Re: FortisBC Energy Inc. (FEI)

Project No. 1599152

**Application for a Certificate of Public Convenience and Necessity for the
Okanagan Capacity Upgrade (OCU) Project (Application)**

**Response to the British Columbia Utilities Commission (BCUC) Information
Request (IR) No. 1**

Fig. 1 Major Gate Station Inlet Pressure - Peak Day 2019-2024

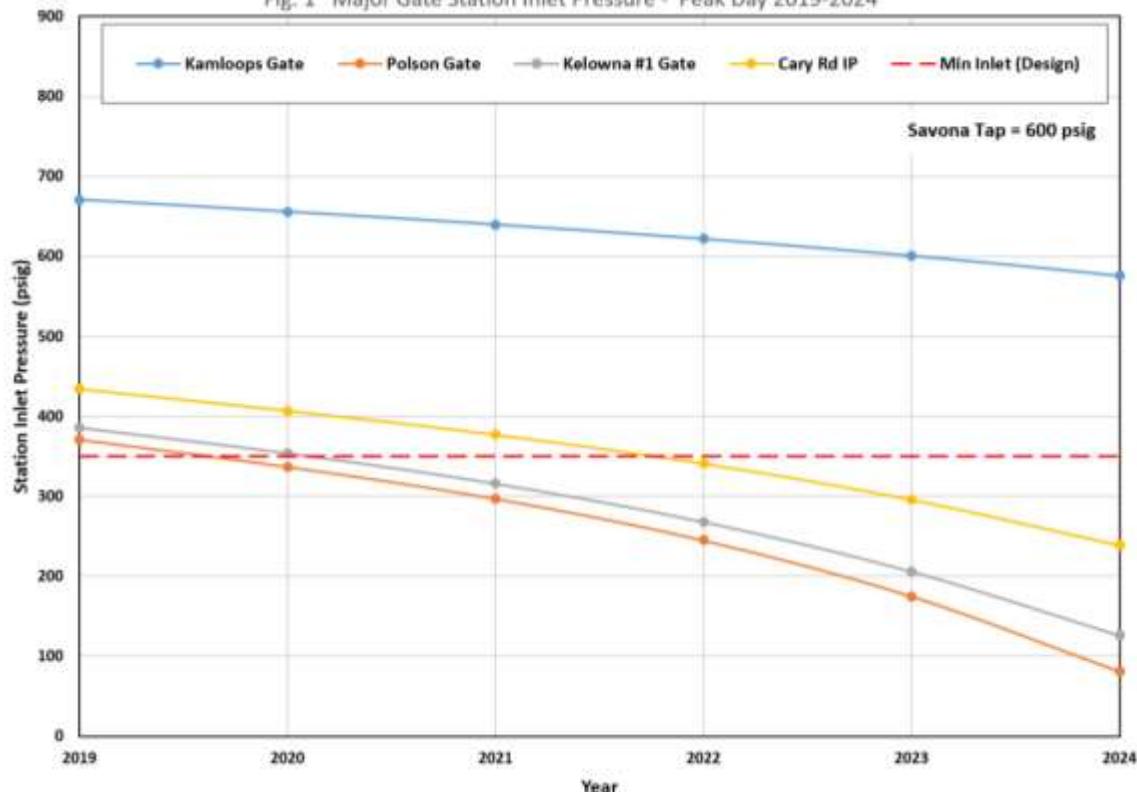
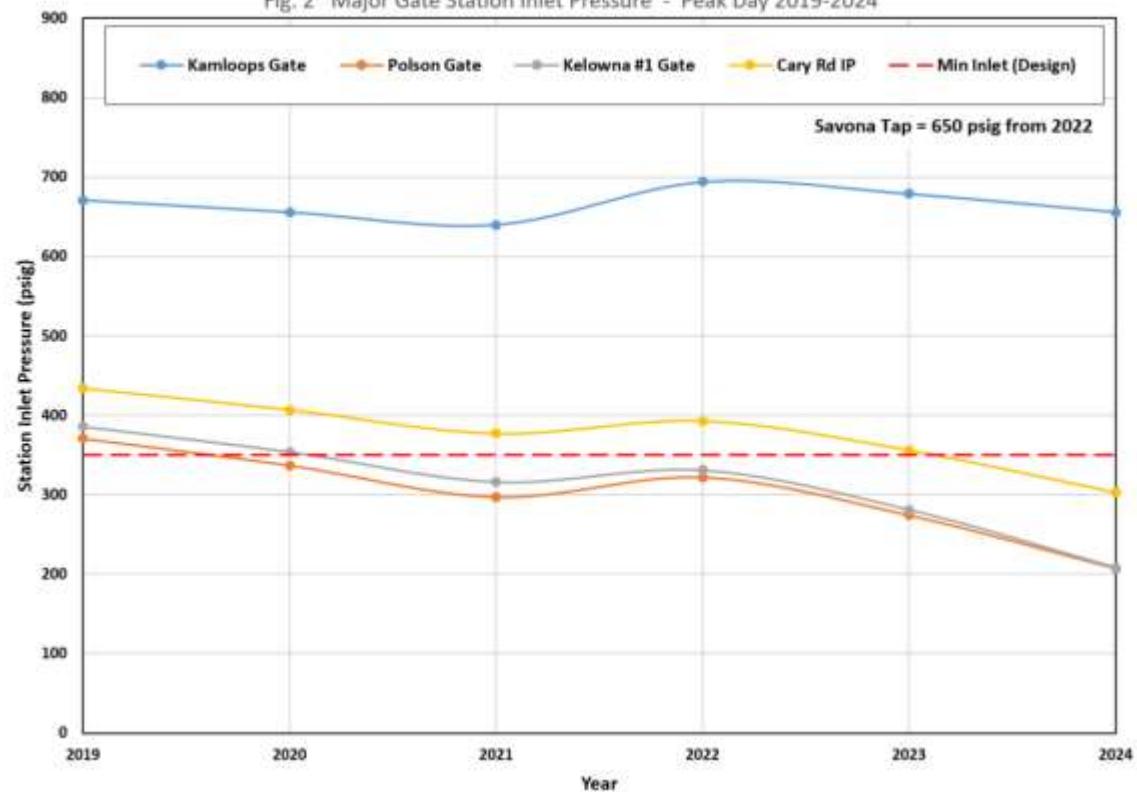
21
22 2.5 Please provide graphs for the Kelowna #1 Gate Station and the Polson Gate
23 Station which show from 2019 to 2039 the forecasted inlet pressure under
24 forecasted peak day conditions in the absence of the OCU Project.

27 Figure 1 below shows the station inlet pressure of major ITS gate stations from 2019 to 2024
28 under forecast peak day conditions in the absence of the OCU Project. Figure 2 shows the
29 minor improvement that would result from increasing the Savona tap pressure from 600 psig to
30 650 psig in 2022 to offset the pressure decay for a period of time. Beyond 2024, the hydraulic
31 model no longer converges, which indicates that the system would effectively collapse to zero
32 pressure under the sustained peak day load.

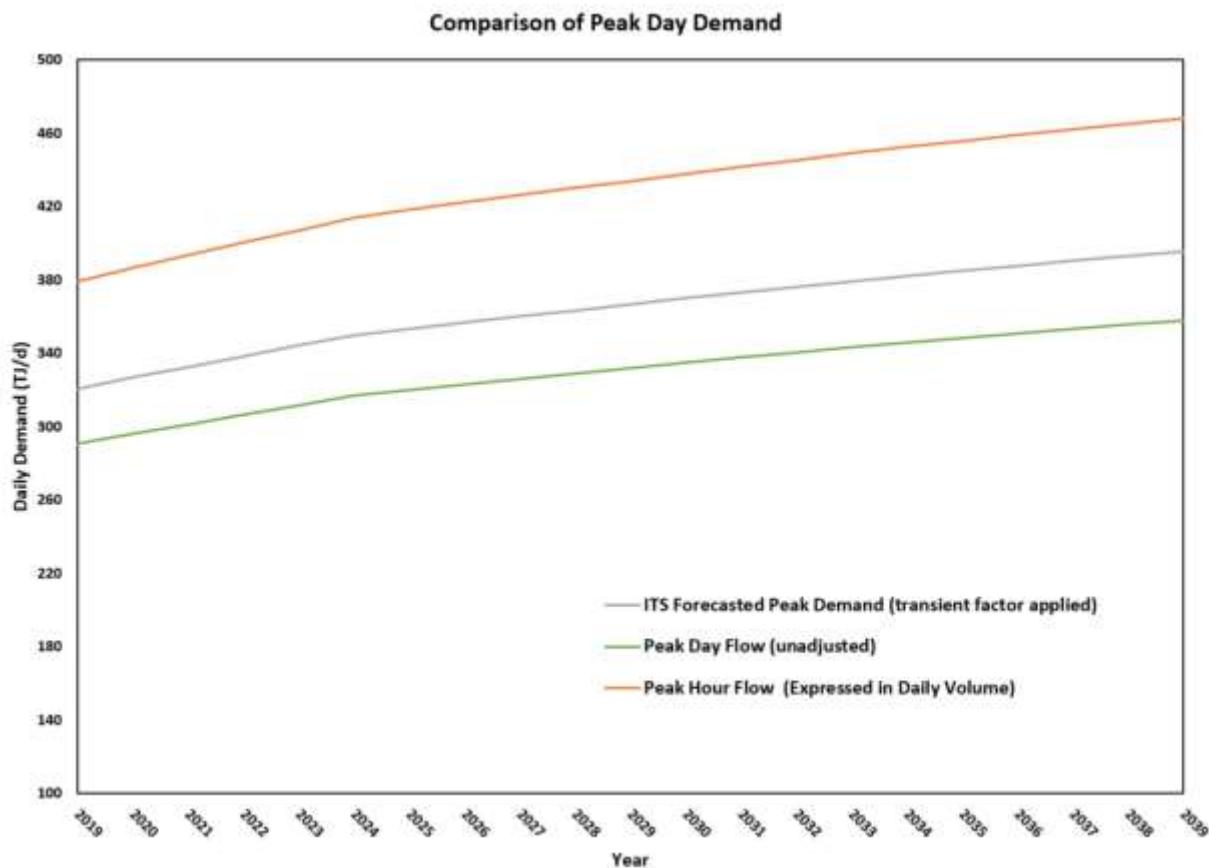
17 3.1.2 Please show a comparison of the peak day forecast for the ITS
 adjusted for the transient factor and unadjusted for the transient factor,
 for the forecast period. If available, please also provide the peak hour
 forecast for the ITS.

20 The figure below provides the requested comparison. The middle curve is the ITS peak
 21 demand forecast provided in the Updated Application.

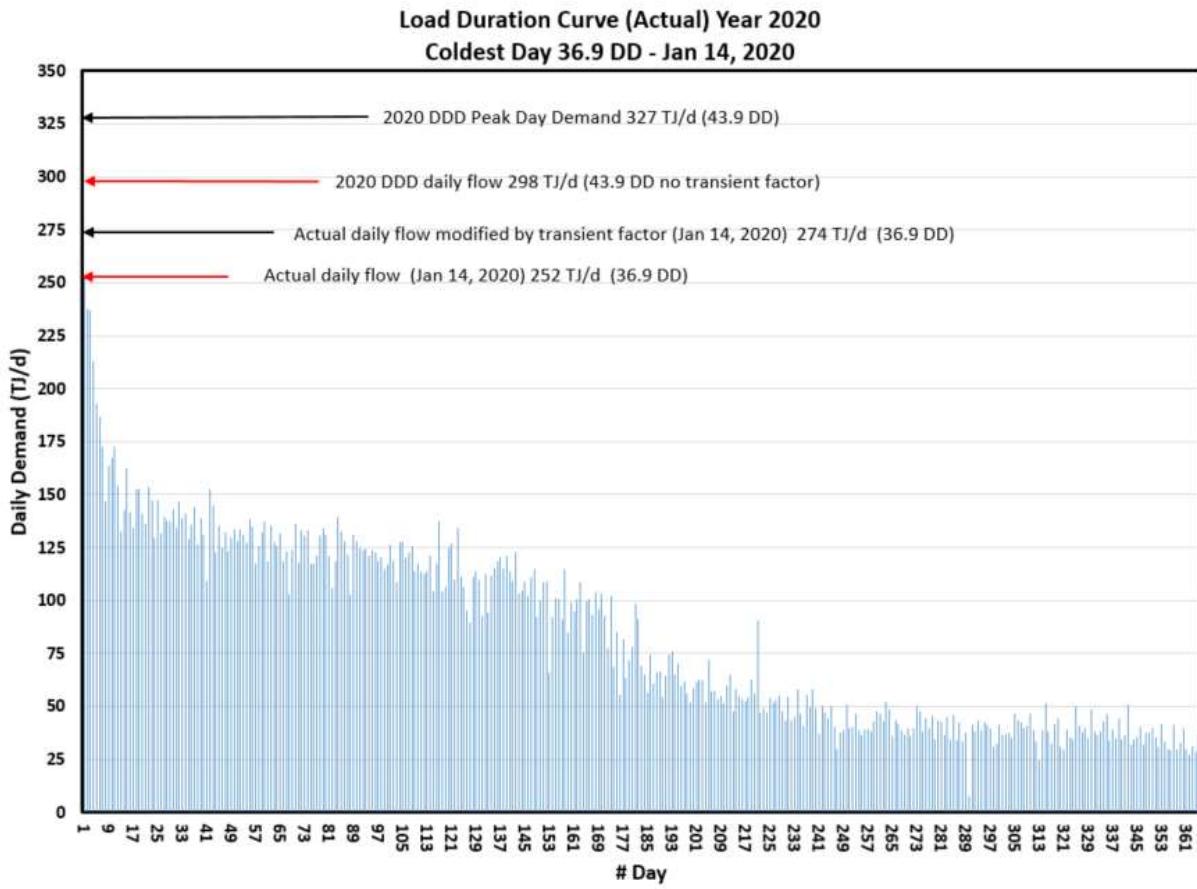
20
21 3.3.1 Please provide a load duration curve showing the daily peak demand
22 on the ITS for the year with the coldest peak day observed in the last
23 five years.
24

26 The figure below presents the load duration plot of daily demand in the ITS for 2020, the year
27 with the coldest day observed in the last five years. The demand for the coldest day and then for
28 each successively warmer day is laid out left to right representing each day of the year. The
29 degree day (DD) on the coldest day was a 36.9 DD (-18.9 ° C recorded at the Kelowna Airport
30 on January 14, 2020). The peak load that day was 274 TJ per day. The red arrows indicate the
31 demand in unadjusted form for the flow on January 14, 2020 and the expected flow on a design
32 degree day (DDD). The black arrows represent the flow adjusted by the transient factor and
33 reflect the actual flows and the expected flow on a DDD as they would be presented against the
34 ITS peak demand in Figures 3-7 or 3-8 of the Updated Application. The variation in daily flows
35 through the year, including during warmer periods, show how industrial demand can vary and

ITS - Historical Rate Schedule 1 UPC_{peak}

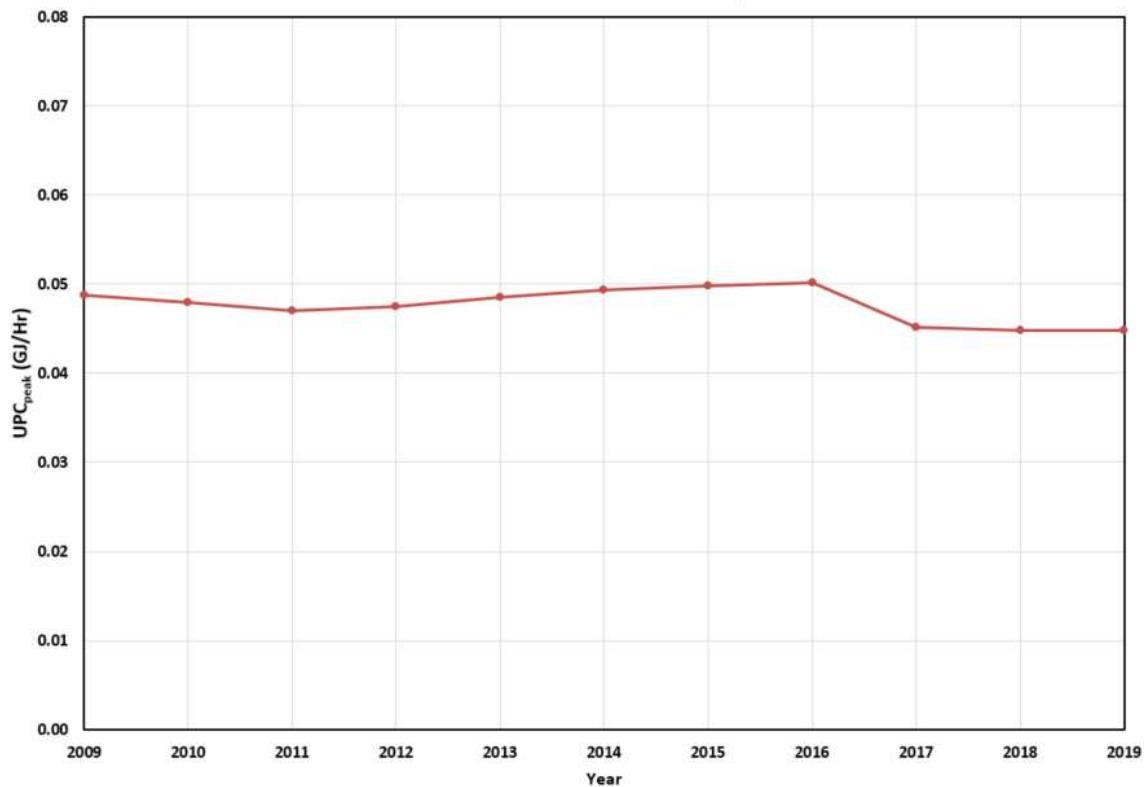
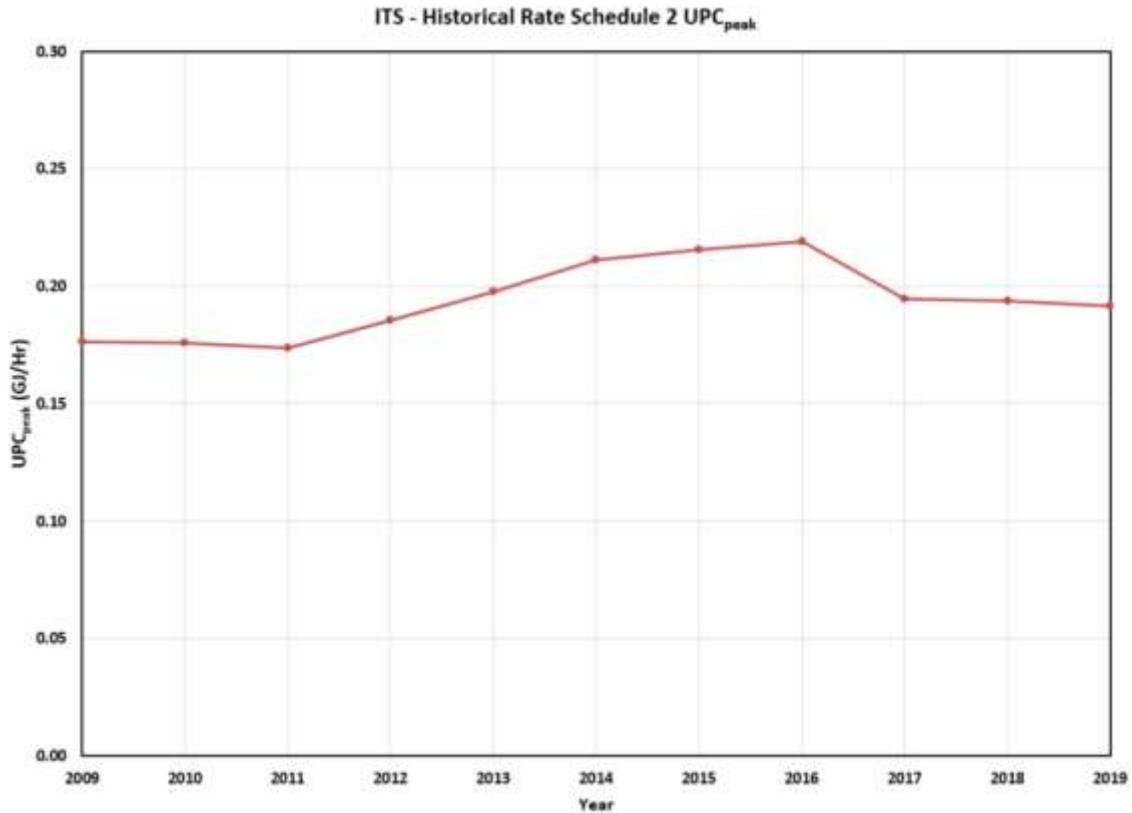
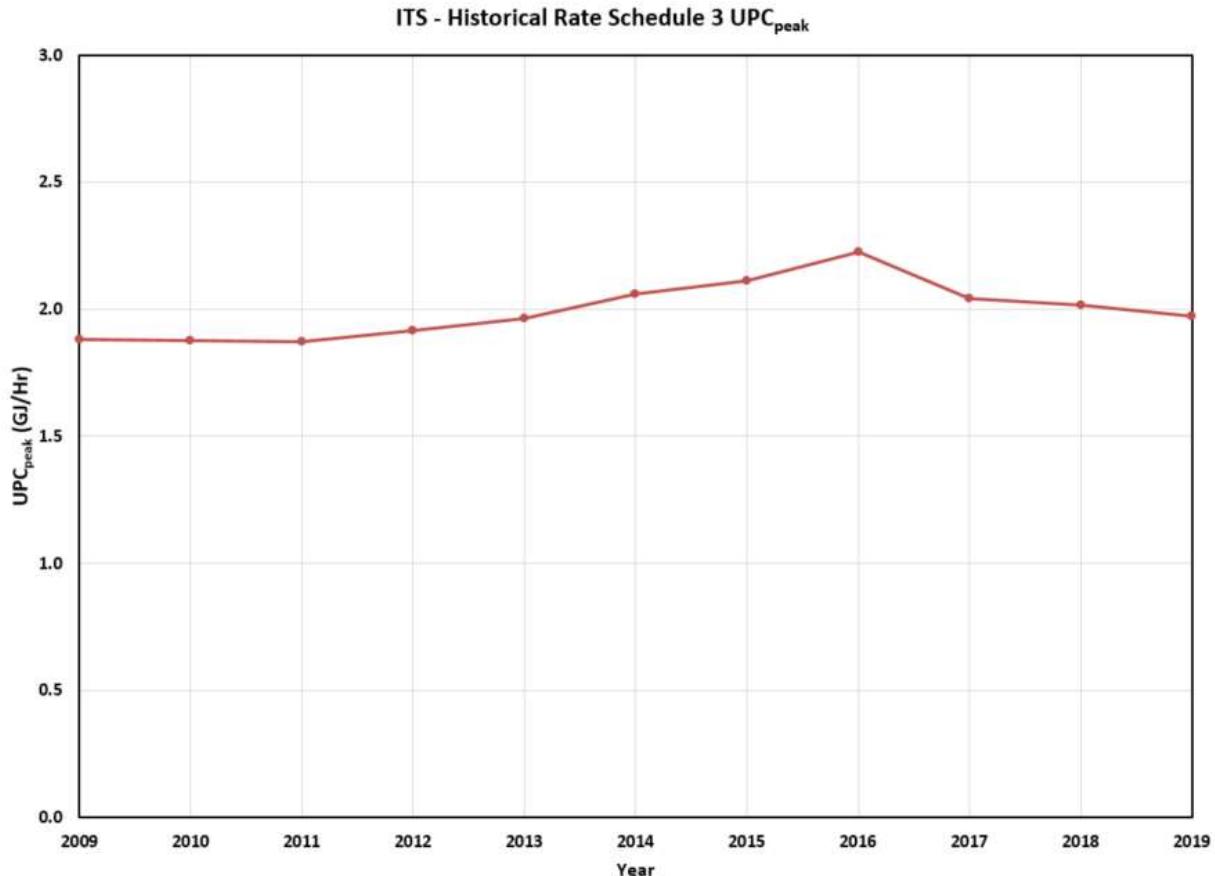
5.3 Please provide the UPCpeak for residential and commercial customers by rate schedule for the last 10 years for customers served by the ITS. Please provide a description and explanation of any observable trends.

37 There are no dramatic trends evident in the UPC_{peak} values over time. The UPC_{peak} for RS1
38 customers drops slightly over the period and mostly in the period from 2017 (primarily due to the
39 DDD change). The UPC_{peak} values for RS2 and RS3 customers have slightly increased when

ITS Capacities for each OCU Project Alternative

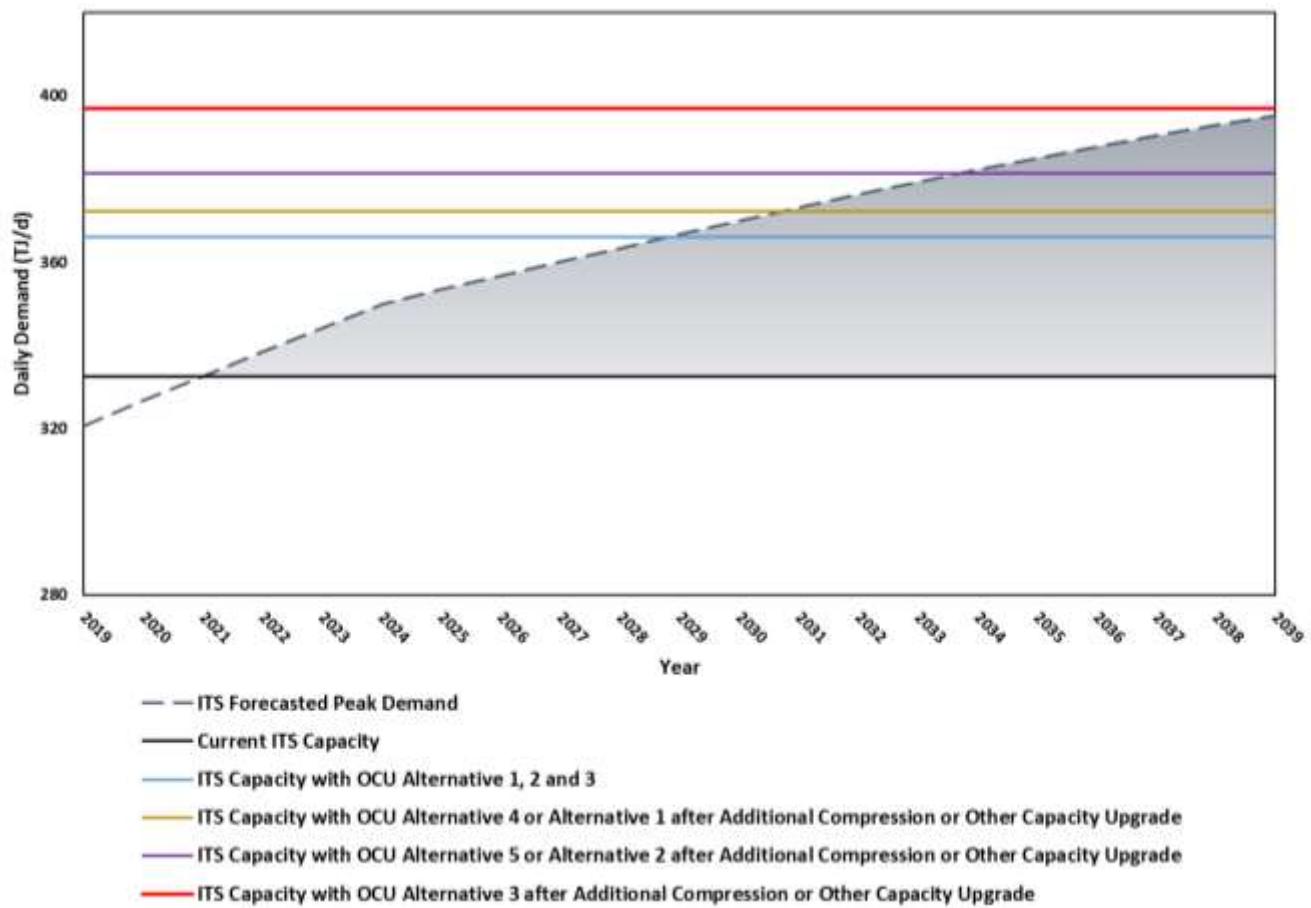
6 13.1 Please provide a graph similar to Figure 3-8 illustrating the capacity of the ITS
7 with each Alternative.

10 The following graph shows Figure 3-8 with an additional line added to show the capacity of the
11 ITS after installation of each alternative. There is effectively no capacity difference between
12 Alternatives 1, 2, or 3 prior to a future capacity upgrade (such as a compressor upgrade at
13 Kitchener), so their capacity is shown as a single line indicating the point at which a
14 compression upgrade, or other capacity solution, as described in the response to BCUC IR1
15 14.3 will be required in 2029. The ITS capacities of each of Alternatives 1, 2, and 3 combined
16 with a future compressor station upgrade at Kitchener (but with no other upgrades) are also
17 shown in the graph.
